Compliance of mod 621 and alternatives with EU law – RO (g) and charging RO (e)

Existing Contracts issues impacting on other Relevant Objectives

Comparison of non-storage entry prices using PS model V 2 with existing contracts average prices

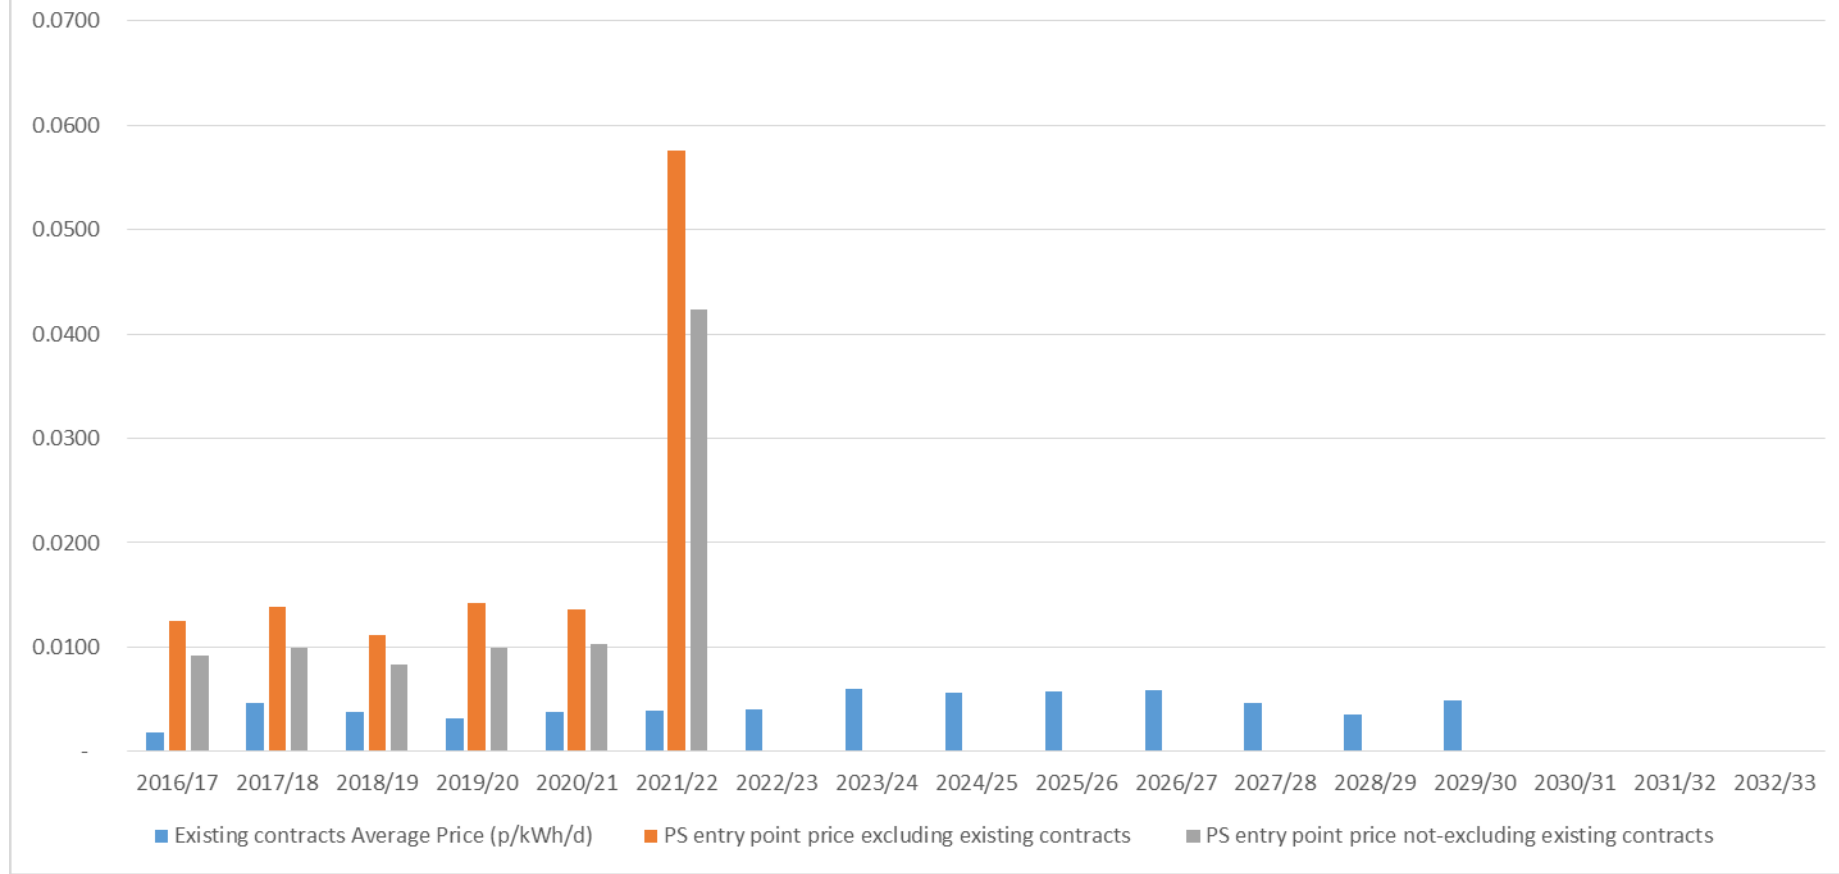
Capacity prices will change year on year as existing contracts expire where existing contracts are excluded prior to the reference price calculation – the graphic below can be populated with these values when available.

Is there an impact on competition here ? is this an undue distortion ?

Query logic of NG’s FCC forecast in enduring period at exit using DN bookings but at entry not using existing bookings in the same way ?
